PROPOSED FORMPAVE PERMEABLE PAVING SYSTEM

INSET A

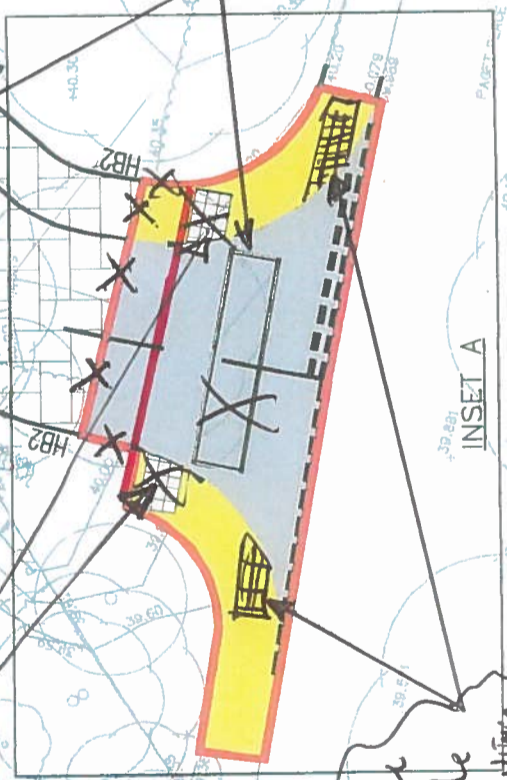
Relocate Rumble Strip (Away From Base)

Provide Footways into Site @ 2.0m in width Not 1.8m

Delete

Provide tactile paving
